Meeting Agenda Plat Committee

Monday, March 21, 2022

1. [KPB-4007](#) Clan Maxwell Estates Woodland Hollow Addition
KPB File 2022-017
Attachments: [E1-Packet Clan Maxwell](#)
2. [KPB-4008](#) Playle Estates
KPB File 2021-159R1
Attachments: [E2 Packet - Playle Estates](#)
[E2 Plat Comment](#)
3. [KPB-4009](#) Grouse Creek Subdivision 2022 Addition
KPB File 2022-022
Attachments: [E3 Packet Grouse Creek](#)
4. [KPB-4010](#) Inglebrook 2022 Replat
KPB File 2022-021
Attachments: [E4 Packet Inglebrook](#)
5. [KPB-4011](#) Katamar Subdivision 2022
KPB File 2022-020
Attachments: [E5 Packet Katamar Sub](#)
6. [KPB-4012](#) Tulin West Highlands Replat 2022
KPB File 2022-019
Attachments: [E6 Packet - Tulin West](#)
7. [KPB-4013](#) Lobdell Subdivision
KPB File 2022-018
Attachments: [E7 Packet - Lobdell Sub](#)

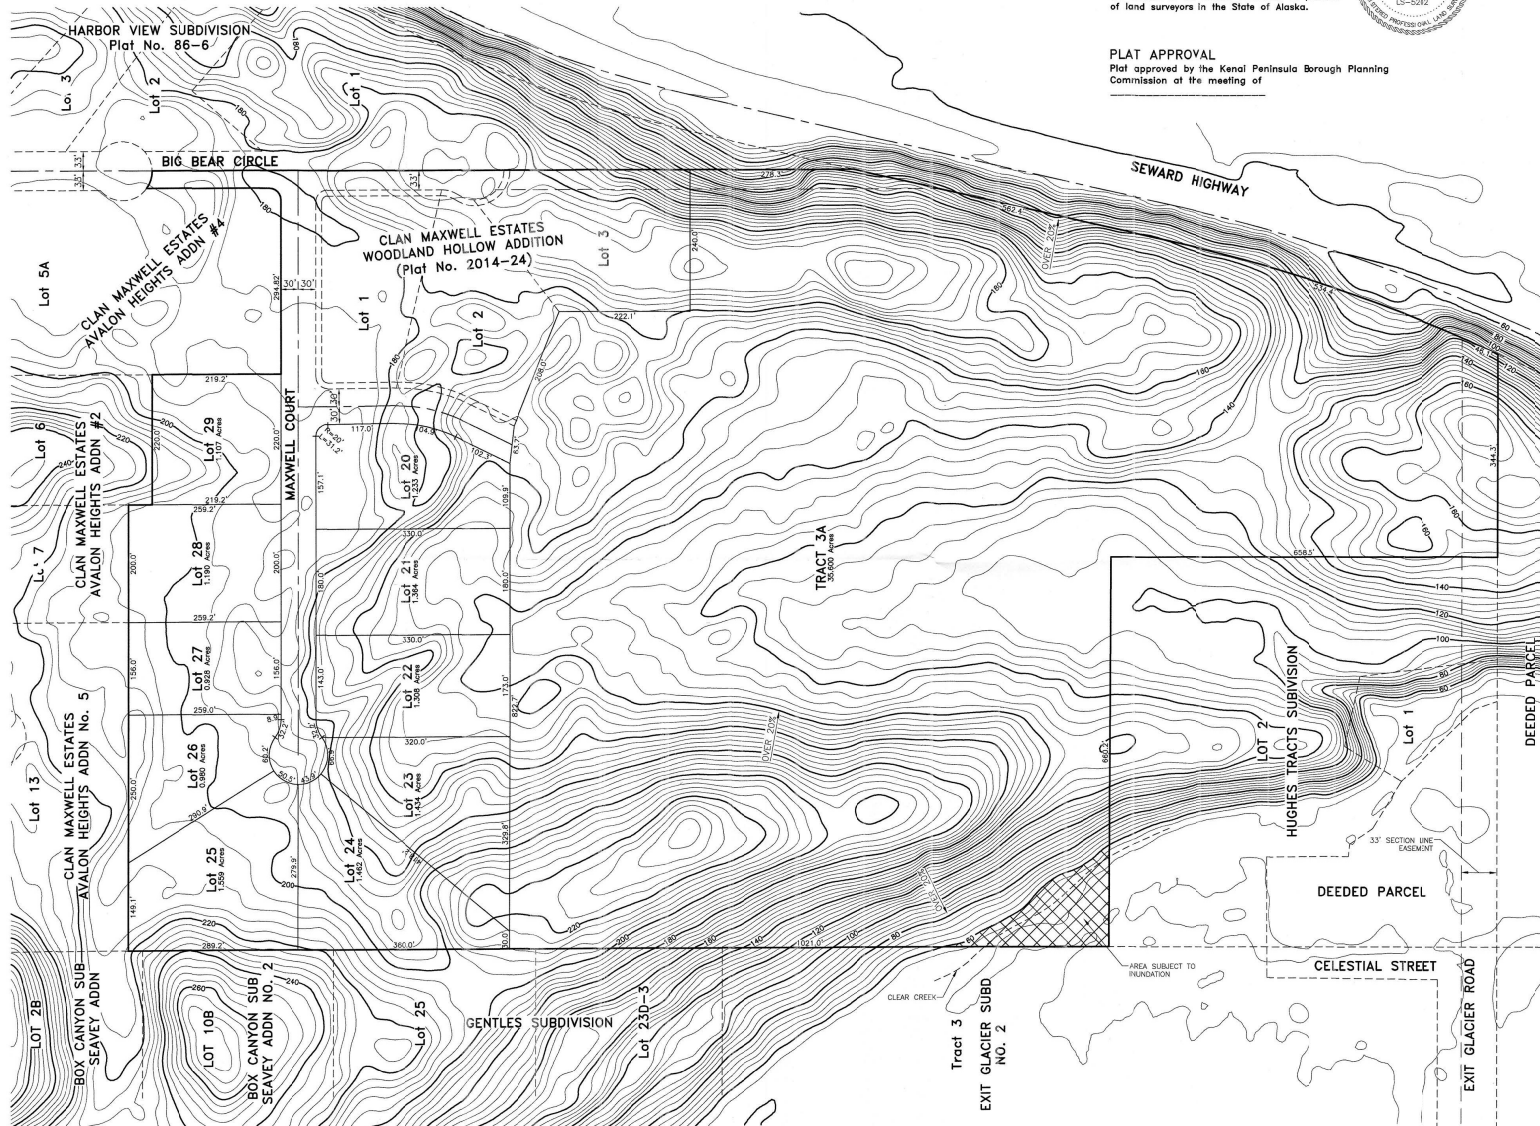
Per the KPB River Center review, the subdivision plat is within multiple flood zones and within the Seward Mapped Flood Data Area. **Staff recommends** a flood hazard note be required, depict and label mapped flood zones, and provide a plat note that references the Map Panel.

A plat note will need to be added to grant 10 foot utility easements along the dedications and should be depicted if possible. **Staff recommends the code required 10 foot utility easements be granted, include depiction, and provide the correct plat notes.**

- *The proposed subdivision name is one of the parent subdivision's name. A new name must be submitted to be approved by Platting Staff. Staff suggests "Clan Maxwell Estates Woodland Hollow Addition 2".*
- *Owners should be added to the title block.*
- *Tract 2D needs the full subdivision name added, "Clan Maxwell Estates Avalon Heights Addition #4".*

- *Provide a width label for the Seward Highway or a "width varies" label.*
- *Provide a reference to the state project map either within the right of way depiction or within a plat note.*
- *The right of way dedicated with Plat No 2014-24 should be more obvious and may be once contours are removed.*
- *The section line easements not within right of way dedications should be depicted and labeled.*
- *Update the road name to "Old Exit Glacier Road" and provide a width label.*

- Provide a width label for Celestial Street.
- The dedication of Celestial Street continues north to the southwest corner of the preliminary plat.

- The depiction should be revised to exclude lots of Plat 2014-24 that are not part of this subdivision.
- There are multiple dark lines present with no labels. Please remove or provide labels.
- There are overstrikes on the section labels and some of the other labels. Make sure all labels are legible.

Staff recommendation: *The boundary must be revised to exclude the lots and right of way dedications that are not included within this subdivision.*

- Add a plat note for any exceptions granted that includes the meeting date they were granted.
- If Tract 3A is not included in the soils analysis add, "WASTEWATER DISPOSAL: (Tract 3A) Lots which are at least 200,000 square feet in size may not be suitable for onsite wastewater treatment and disposal. Any wastewater treatment or disposal system must meet the regulatory requirements of the Alaska Department of Environmental Conservation." For the existing note on the plat, add "(Lots)" or "(Lots 20-29)".

Staff recommendation: Verify which state Mr. Maxwell will be signing in and update the Notary accordingly or leave blank. Next to each owner's name, include the parent tract number they are signing on behalf. Include a right of way acceptance to be signed by the borough. Comply with 20.60.190.

NOTES

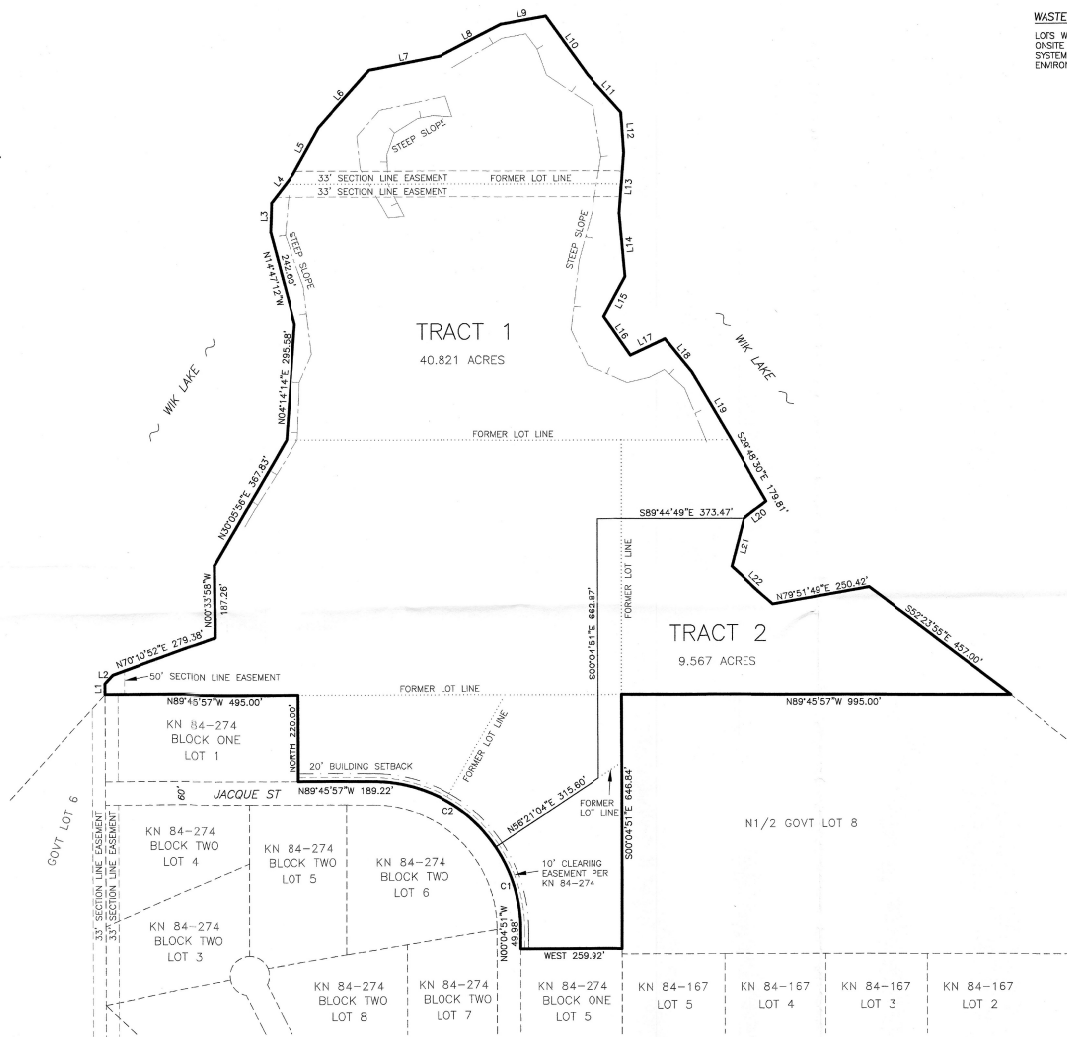
Public Waters. The Supplemental Land Estate Plat done by Alaska DNR included a note that the lots were subject to the public access easements extending 50 feet upland of ordinary high water per AS 38.05.127. The access easement was included on the record of survey performed for the property and recorded as KN 2021-31. Staff was unable to determine if the southern Government Lots were subject to the easement. **Staff recommends a plat note be added as well as a depiction of the easement within Government Lots 4 and 12 and verify if easements are present within Government Lots 5 and 6.**

The proposed subdivision is not within a compliant or closed block. The property within this subdivision is within a portion of land that is a peninsula surrounded by Wik Lake. The ability to get fully compliant blocks within this area is not reasonable. The proposed lots will be large acreage tracts that can be further subdivided and can provide right of ways that meet the block length requirements. **Staff recommends the plat committee concur that an exception to KPB 20.30.170 Block Length is not required as road dedications will not improve the block at this time and the tracts are large enough to be subdivided in the future.**

Staff recommendation: A drive is being used through 3 and 4 of Thompson Homestead Subdivision Happy Hollow Acres Addition to provide access to a new construction on Government Lot 6. An easement has been recorded for the access. The design of the plat will allow the constructed drive to be within one lot.

- Update the page in plat note 5 to 865 and add, "and Amended on January 26, 1990 in Book 359, Page 845, Kenai Recording District.
